Evaluation of proposed move for Water Right No. 51081

Proposed: Increase rate on water right no. 43291 & 51081 from 1830 gpm to 2105 gpm.

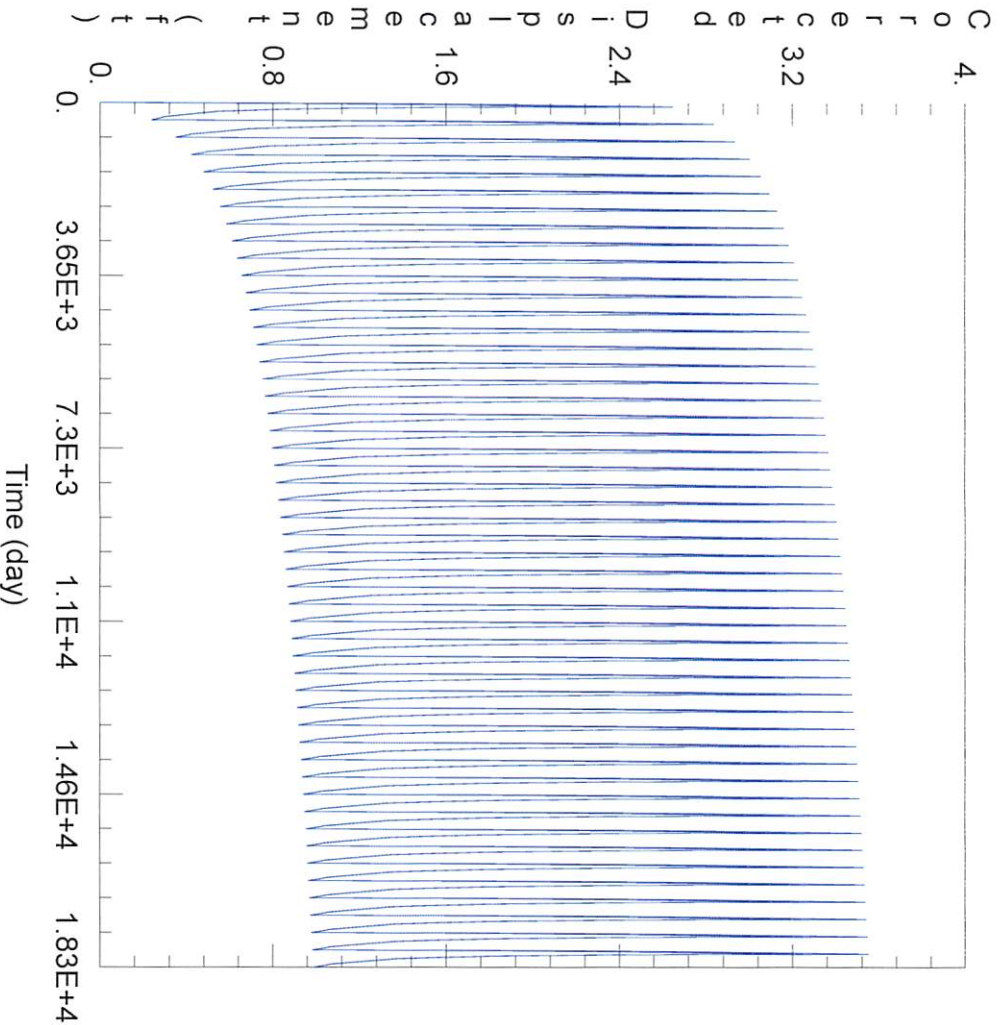
27000: Drawdown from current location = 3.15 ft
Drawdown from proposed location = 3.34 ft
Net drawdown = **0.2 ft**

13428: Drawdown from current location = 3.24 ft
Drawdown from proposed location = 3.45 ft
Net drawdown = **0.2 ft**

43297: Drawdown from current location = 3.55 ft
Drawdown from proposed location = 3.80 ft
Net drawdown = **0.3 ft**

Domestic 31-34-38: Drawdown from current location = 3.24 ft
Drawdown from proposed location = 3.45 ft
Net drawdown = **0.2 ft**

Net drawdown does not exceed the drawdown allowance of 4.0 ft for any well within 1 mile of the proposed location. Therefore, critical well analysis is not necessary.

The proposed move is likely to create minimal effects on neighboring wells and appears unlikely to cause impairment. Any concerned neighbors should contact GMD3 at (620) 275-7147 or the Division of Water Resources at (620) 276-2901.
